Final Environmental Impact Report
City of Healdsburg
Wastewater Treatment Plant Upgrade Project

SCH #2002072083

June 13, 2005

The written and oral comments received on the draft EIR and the responses to those comments are provided in this section. Each comment letter is reproduced in its entirety and is followed by responses to comments on substantive environmental issues. The oral comments from the public hearing are summarized in meeting minutes and also are followed by responses to comments on substantive environmental issue

Figure 4-1 - Boundary of 100 Year Floodway In The Project Vicinity

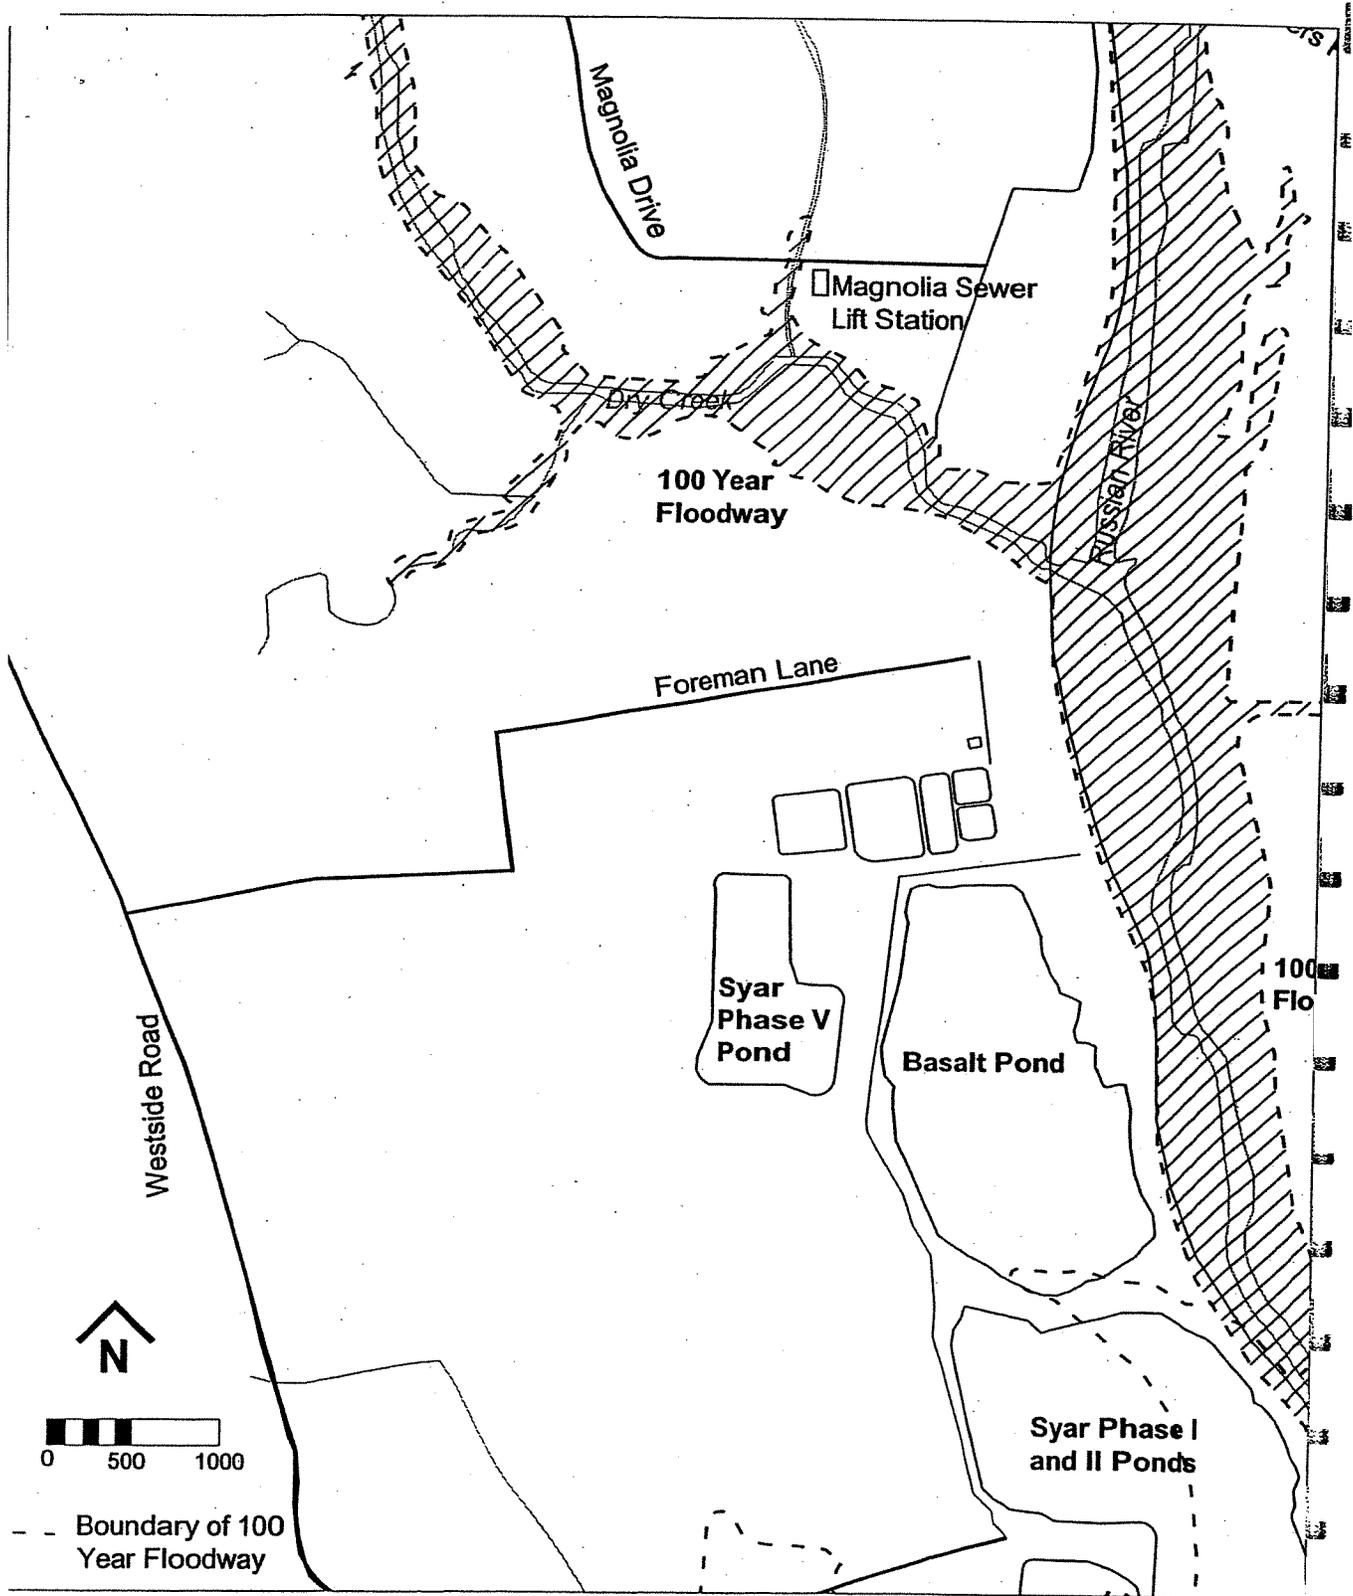
10. Page 5.2, 4th bullet – The Basalt Pond also appears to be located outside the 100-year flood zone in Figure 4-2. However, two levee breaches occurred within three years due to flooding of the Russian River. It is not clear how the location of the site relative to the 100-year flood zone is sufficient to ensure protection against future commingling of wastewater and surface water from the Russian River during future flood events. A more appropriate statement would be that flood waters from the Russian River would be prevented from reaching the Phase V Pond because the Basalt Pond would capture the flood water.
